<p align="center">COMMITTEE OF ADJUSTMENT REPORT SUMMARY MINOR VARIANCE APPLICATION FILE NUMBER A268/21</p>
---	--

AGENDA ITEM NUMBER: 6	CITY WARD #: 4
APPLICANT:	[REDACTED] & Yang Zhou
AGENT:	Bhaskar Joshi
PROPERTY:	150 Valley Vista Drive, Maple
ZONING DESIGNATION:	See below.
VAUGHAN OFFICIAL PLAN (2010) DESIGNATION:	Vaughan Official Plan 2010 ('VOP2010'): "Low-Rise Residential"
RELATED DEVELOPMENT APPLICATIONS:	None
PURPOSE OF APPLICATION:	Relief from the Zoning By-law is being requested to permit a proposed side door entrance, stairs and hard landscaping to be located on the south side of the existing dwelling.
	The proposed side door entrance is to accommodate a secondary suite.

COMMITTEE OF ADJUSTMENT REPORT MINOR VARIANCE APPLICATION A268/21

SITE PLAN A-1

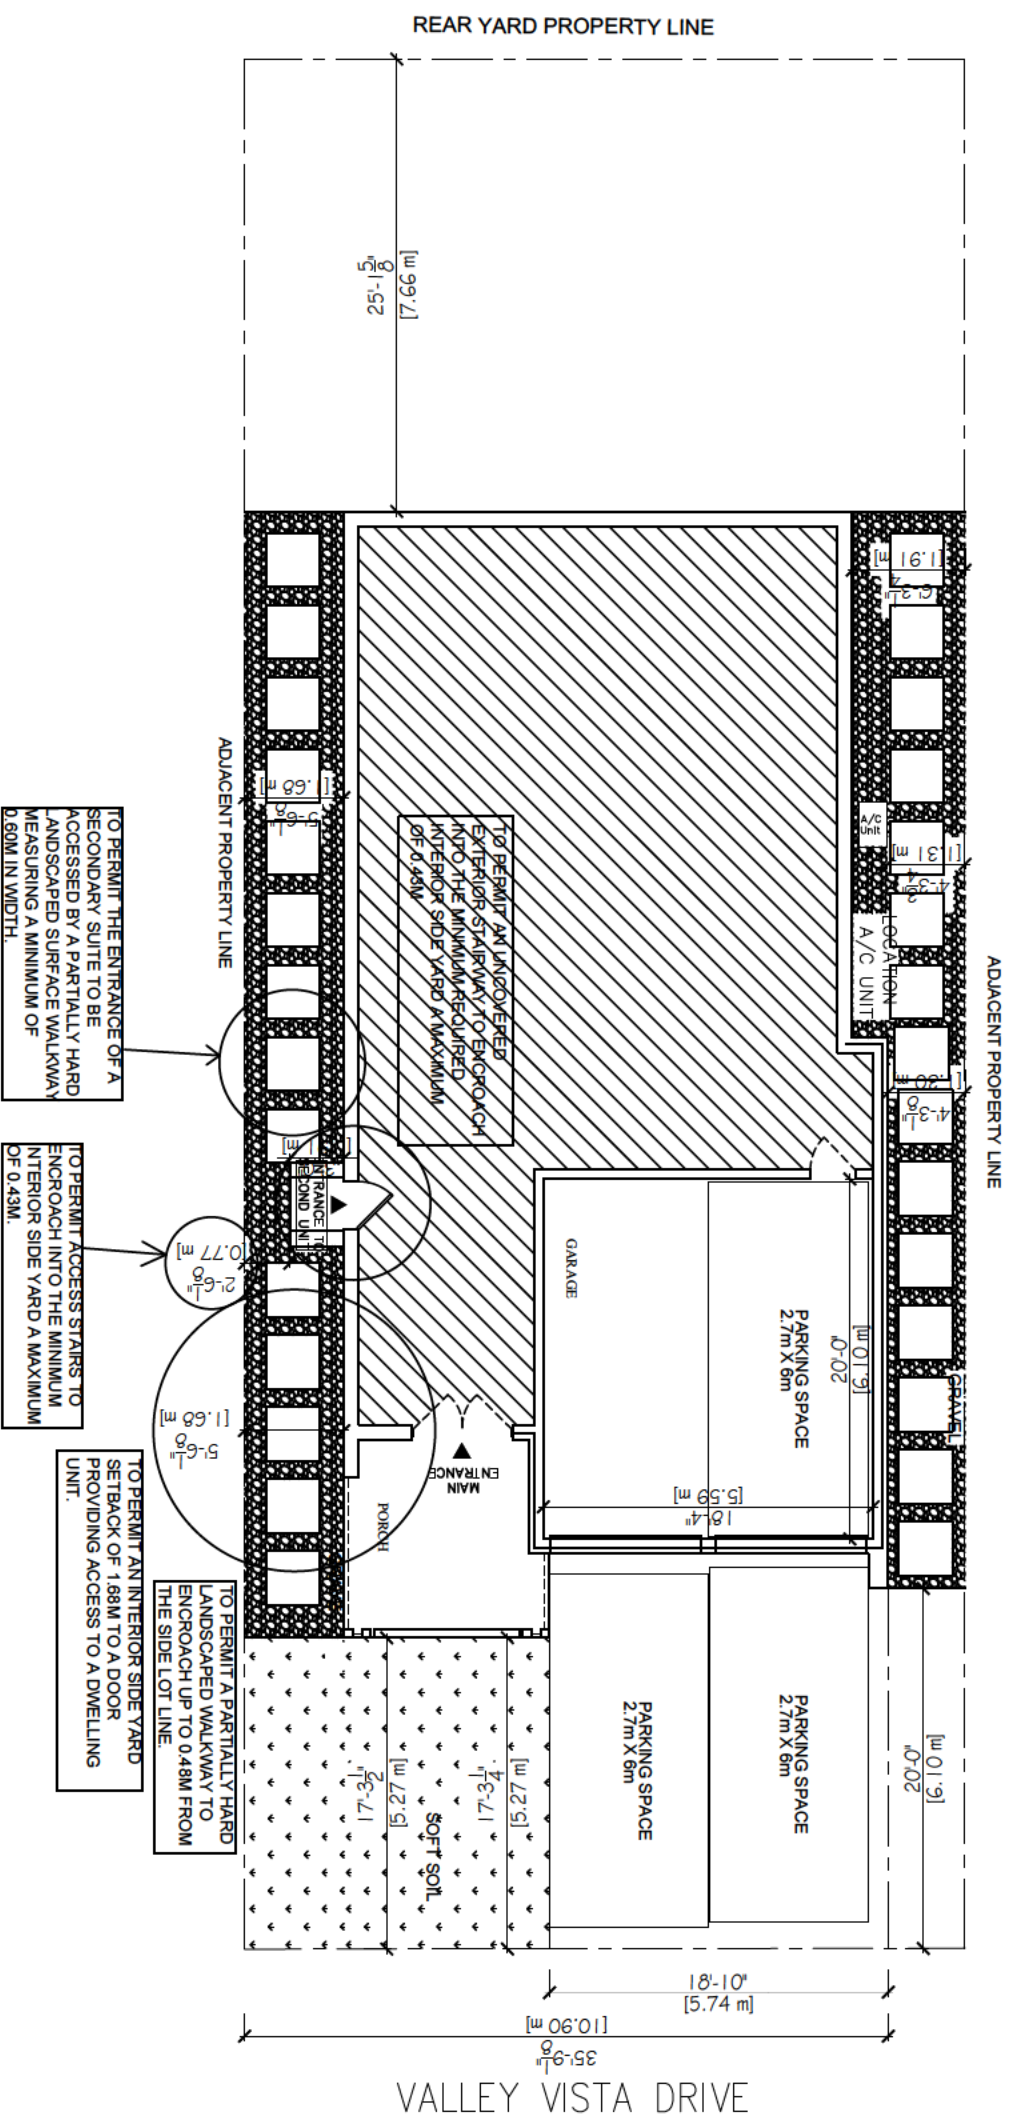
The Development Planning Department has no objection to Variance #1 as the proposed hard landscape walkway will consist of a permeable gravel surface, which the Development Engineering Department has reviewed and is satisfied that drainage along the side yard will be maintained. Regarding Variances #2 and #6, the Development Planning Department recognizes the intent is to provide a 1.2 m of undisturbed hard landscape, however, is of the opinion the hard landscaping (0.6 m) and gravel surface (1.08 m) together uphold the general intent of the By-laws which is to provide safe access to the side entrance. The remaining variances (#3, #4, and #5) are considered minor as they do not impact the functionality of the walkway.
